Estimate for the Construction of a III Class
D. B at Anathiragalle in Kadur Taluk

Report to accompany the estimate for Construction of a IIIrd class Travellers Bungalow at Anturagalle.

New estimate of the probable Cost of Constructing a third class Travellers Bungalow at Antinagatto in Kadur Taluk

II nd Class Travellers Bungalow

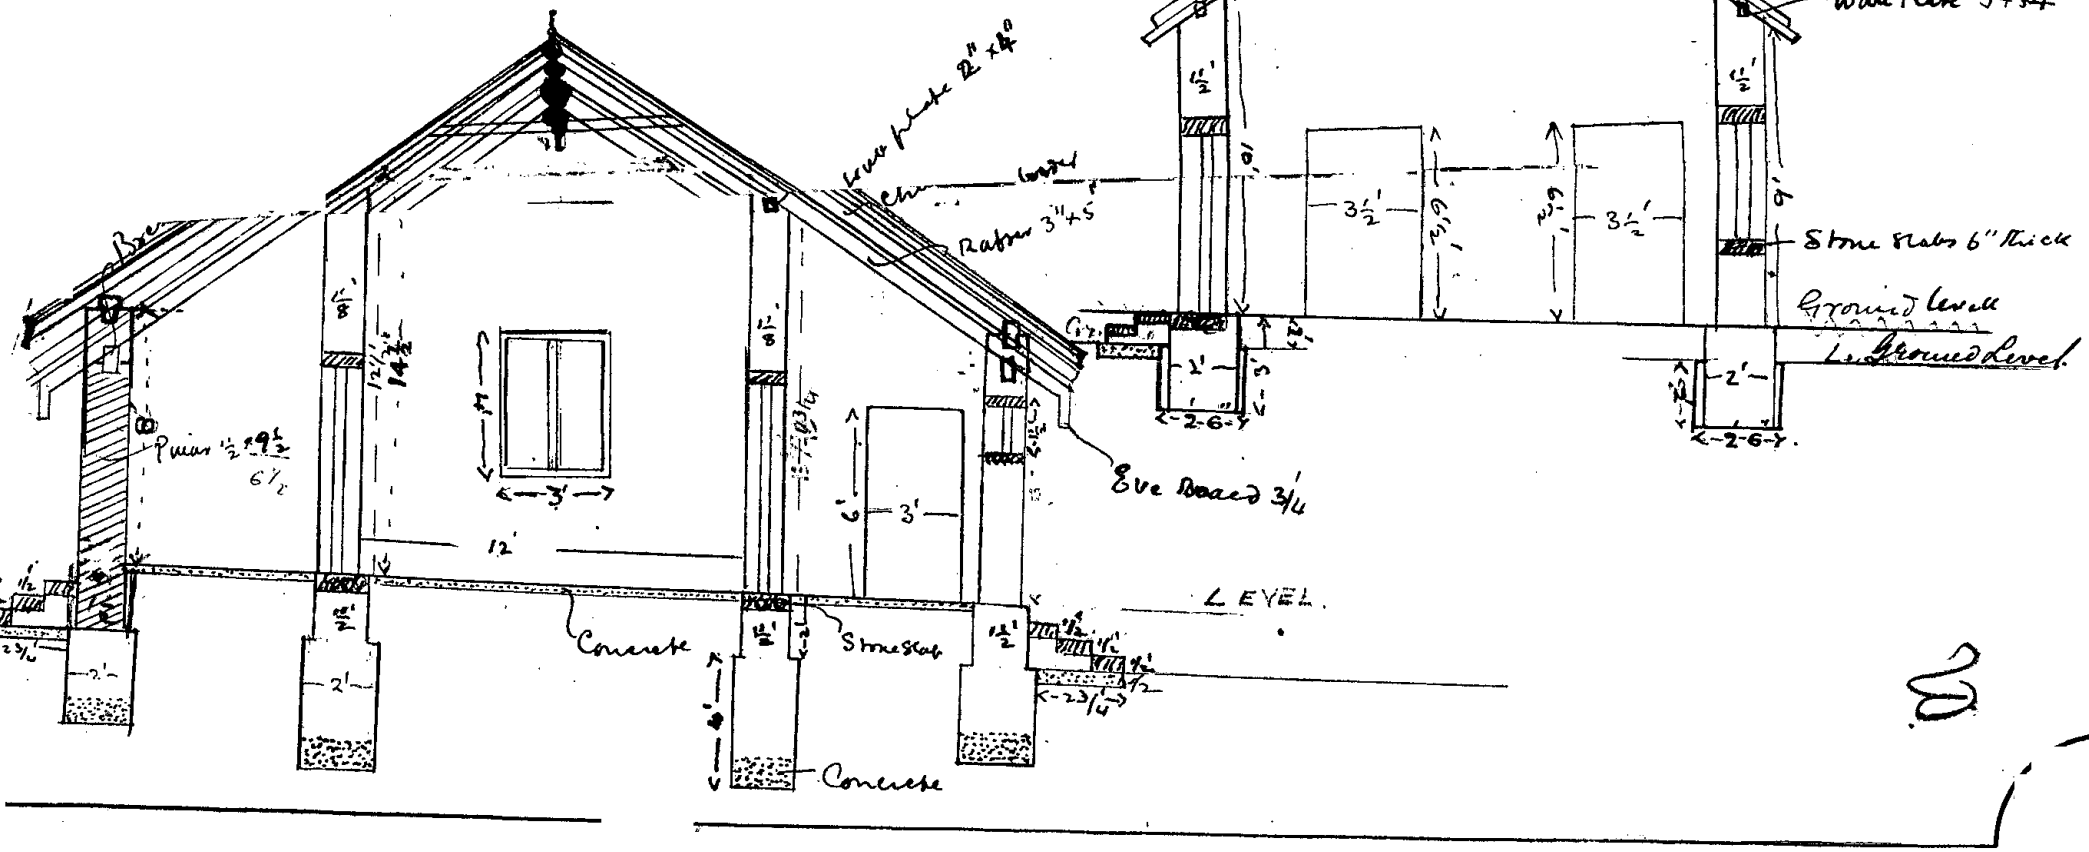
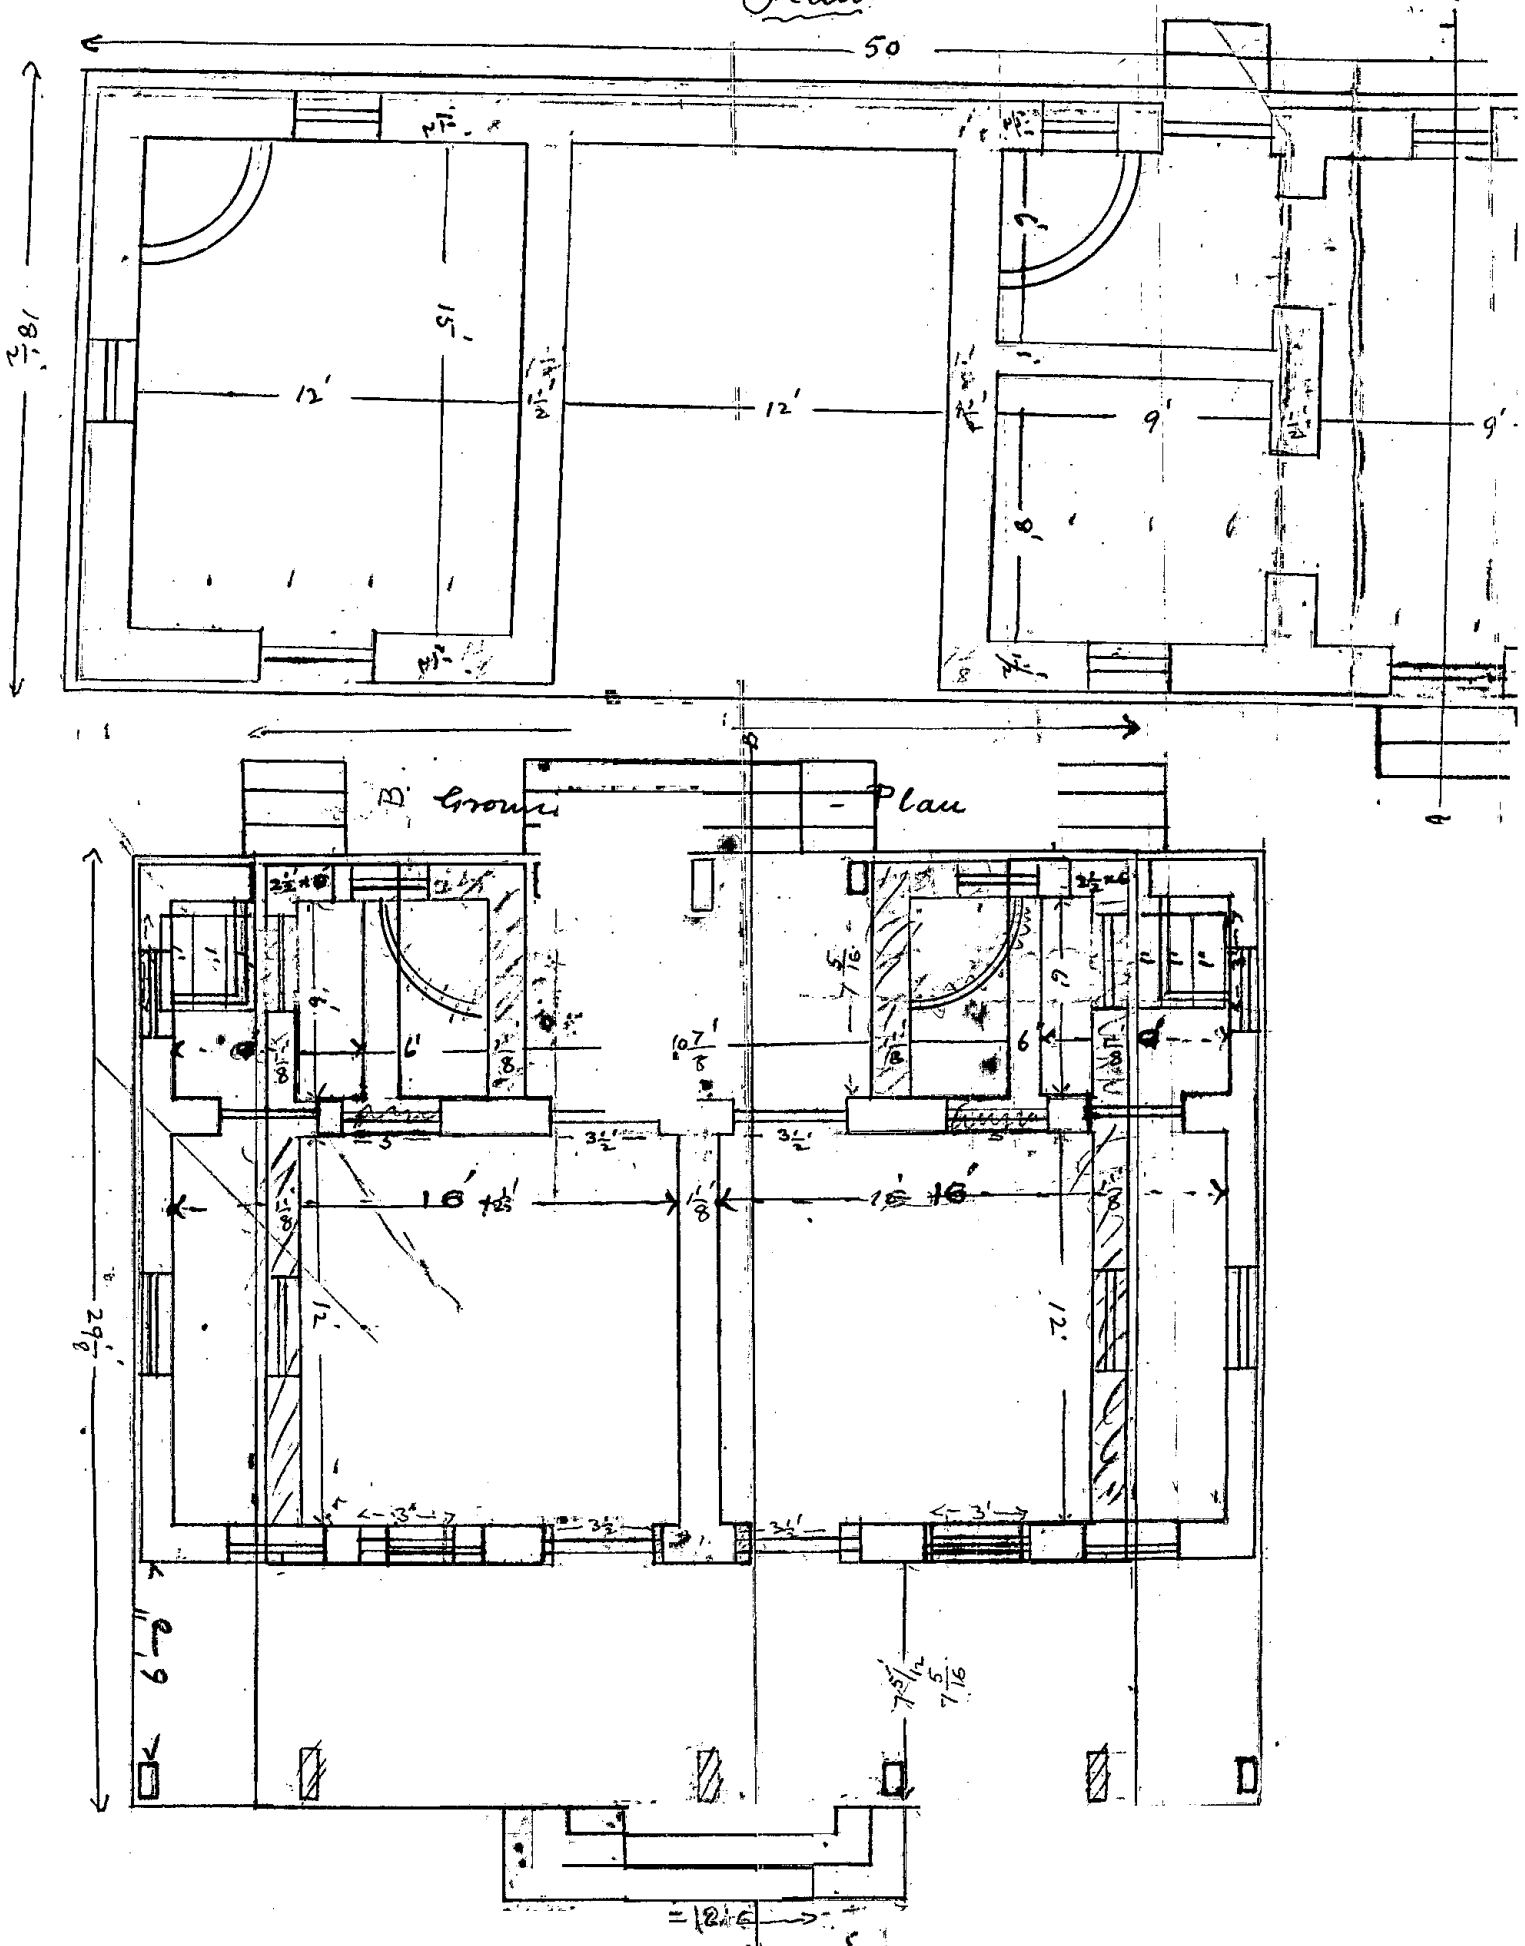
2. The estimate as prepared by the Sanitary -- Inspector under the Taluk Board and as checked by the Executive Engineer is seen to require many --- corrections and is not capable of scrutiny, as --- full information is not furnished nor is the ----- usual report to accompany such estimates received therewith-

Forwarded with compliments to the Executive Engineer, Kadur Division for favor of scrutiny and early return of the Estimate I think the room of the bungalow shd be at least 12 X 16 ft. The estimate may kindly be revised accordingly

The bath room the doors shd go to the back and not be placed on both sides

Design :- This design consists of two rooms 12'x12' each Two bath rooms 6'x6' each, rear Verandah 10 1/8' x 7 5/16' and a front Verandah 27 3/4' x 7 5/16'
